Service Bulletin Index

Bulletin No. RE-1
 Date DECEMBER 20, 1974
 Page 1 of 3

RES SERVICE MANUAL CORRECTIONS AND ADDITIONS

SUBJECT: CARBURETOR FUEL FILTER

ADVANCE INDICATOR LINES

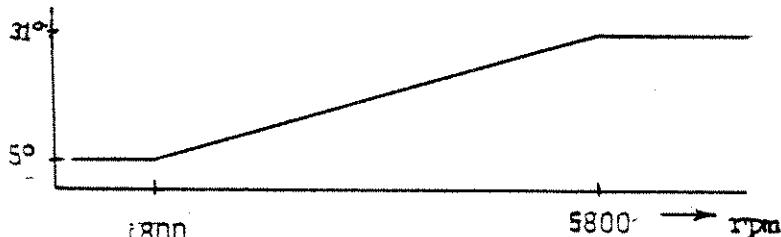
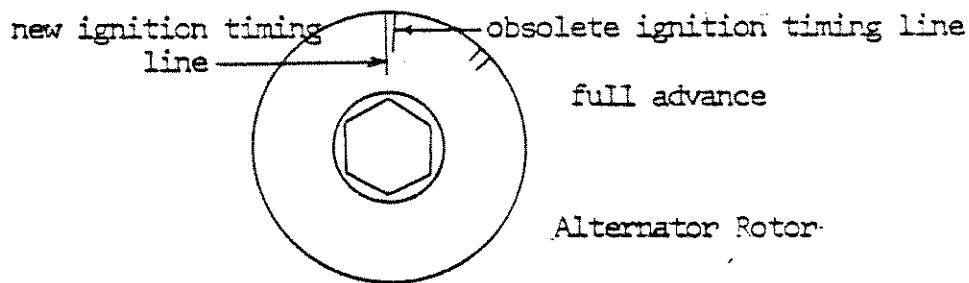
Please note that the ignition timing and its advance characteristic in the production type RE-5 are explained as follows:

* IGNITION TIMING 5 degree B.T.D.C. at idling speed.

When checking the ignition timing advance, use the longest line shown in the illustration for setting the pointer wire to it referring to the idling ignition timing; the line next to it (obsolete line) will give 4 degrees difference from the specification.

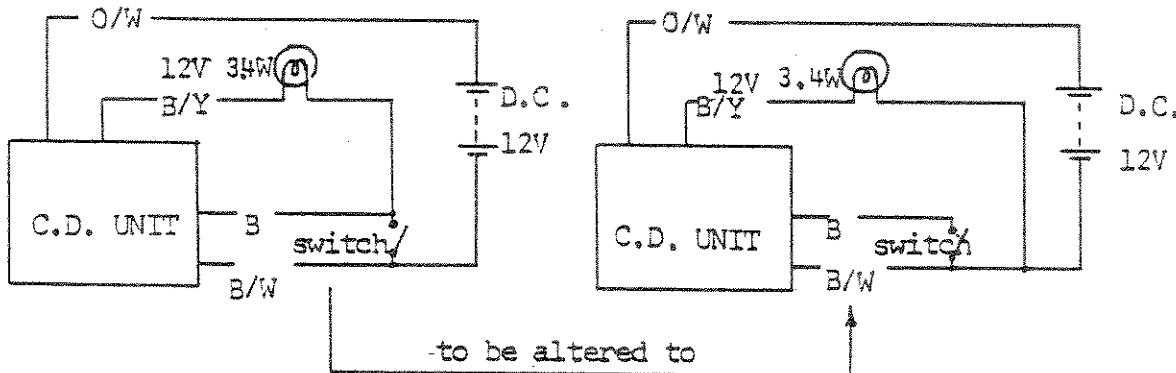
Please alter the illustration "Fig 8-4 C.D. Unit check circuit" in the page 76 as shown below.

The existing check circuit in the manual can still be operable and the lamp lights as good as the altered circuit shown above. This operation, however, may damage the element inside the C.D. unit; whereas the altered one does no harm.

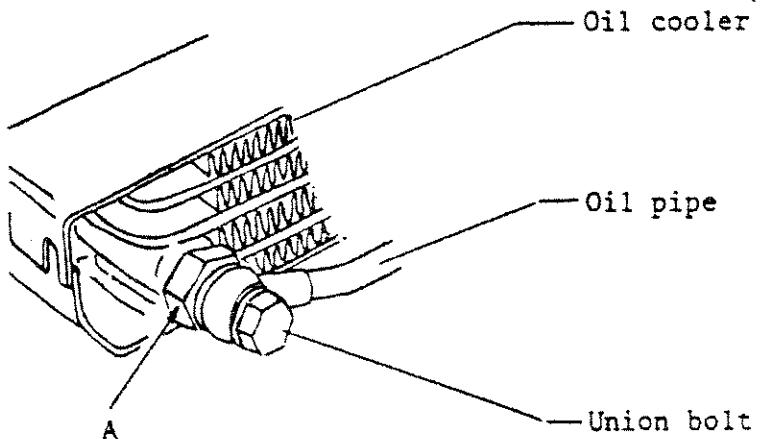
This is intended to call your attention to a proper procedure to tighten the oil pipe joint at the oil cooler on the model RE5.

Please be sure to hold the indicated "A" securely with a wrench when tightening the union bolt. Tightening the union bolt with part "A" unrestrained applies undue stress to the oil cooler which may result in damage.

Damage of the oil cooler can also result in serious damage to the engine. Therefore, please follow the above instructions whenever tightening the oil pipe.

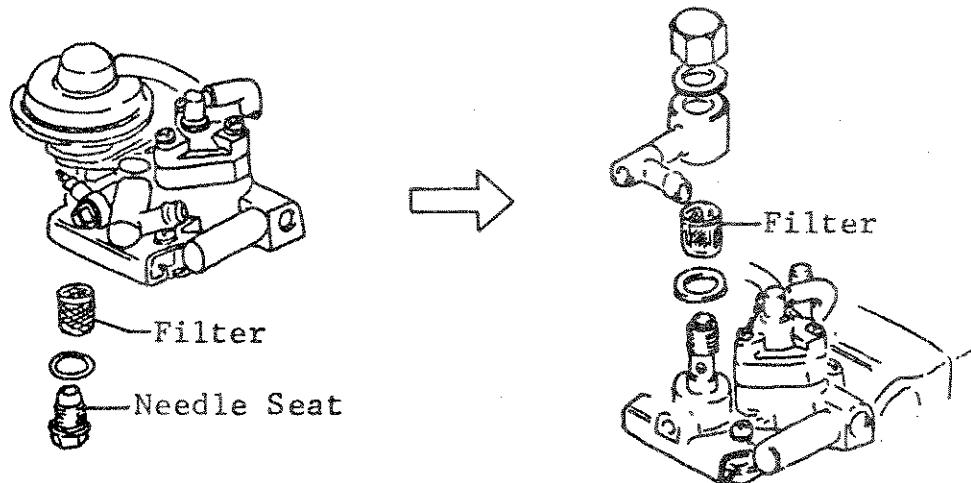
II. PROBLEM:

To service the carburetor fuel filter requires removal of the float chamber top and the needle seat.

The construction of the carburetor fuel inlet has been modified to provide easy access to the fuel filter.

This modification has been included from and including engine number RE5-13054.

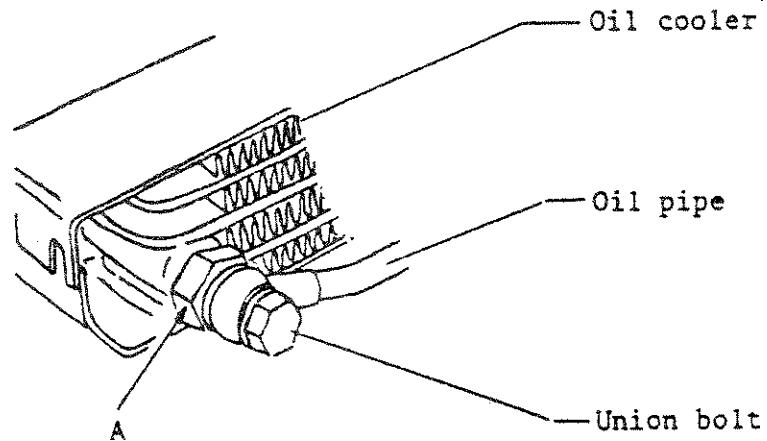
This is intended to call your attention to a proper procedure to tighten the oil pipe joint at the oil cooler on the model RE5.

Please be sure to hold the indicated "A" securely with a wrench when tightening the union bolt. Tightening the union bolt with part "A" unrestrained applies undue stress to the oil cooler which may result in damage.

Damage of the oil cooler can also result in serious damage to the engine. Therefore, please follow the above instructions whenever tightening the oil pipe.
